Project description . . . : ~~ADD OF PORTAL @ E. ELEV;~~ ADD @ SW CORNER
 Project number : 95- 10100071
 Case Number : H-95-71
 Project type : HISTORIC DESIGN REVIEW BOARD
 Application date . . . : 05/01/95

memo

CASE #H-95-71 ADDRESS 424 San Antonio

CITY OF SANTA FE
DOWNTOWN AND EASTSIDE HISTORIC DISTRICT CASE SYNOPSIS

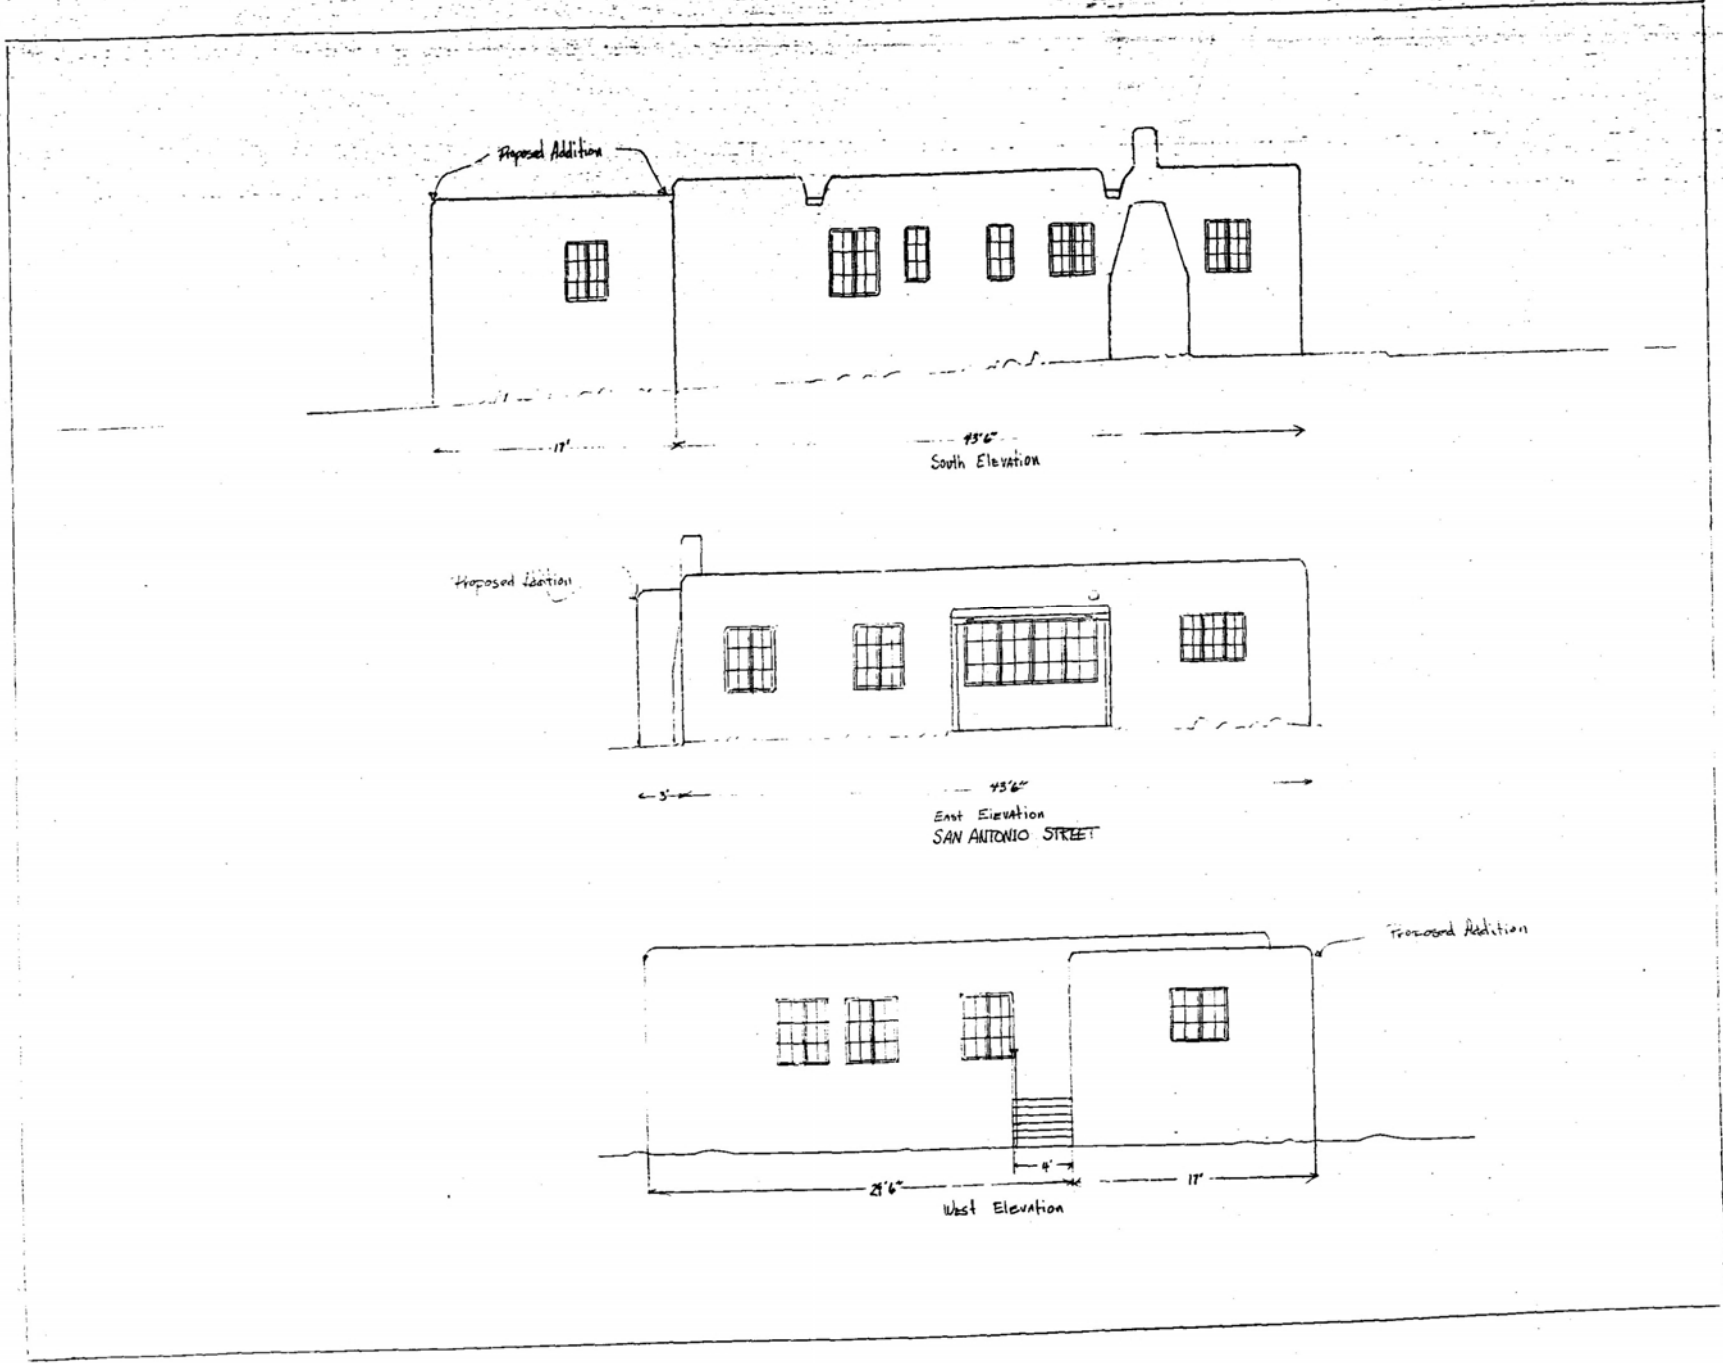
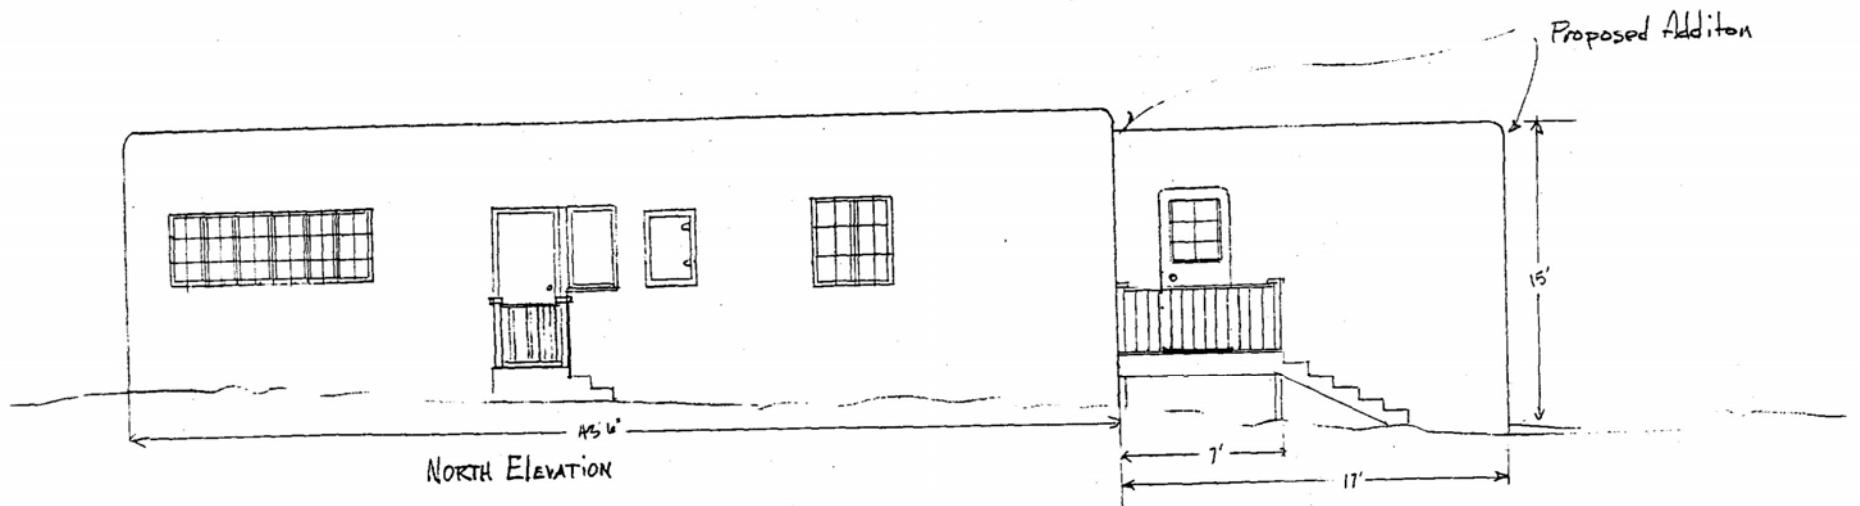
This is to certify that the Historic Design Review Board at its meeting on May 9, 1995, acted on the above referenced case. The decision of the Board was to conditionally approve your request. You shall make part of your Building Permit application any conditions imposed by the Board which are listed as follows: Windows shall have true divided lights, and the steps at the north elevation shall be stucco rather than wood.

Section 14-70.73B(3) of SFCC. This historic building has been altered very little over time and retains much of its original massing, scale, features, and materials, hence its significant status. According to the historic district's ordinance, a primary facade is defined as "one or more principal faces or elevations of a structure with features that define the character of the structure's architecture." The E elevation is one of the primary facades of this structure, and the addition of a portal at this primary facade is not appropriate. The applicant is aware of this issue.
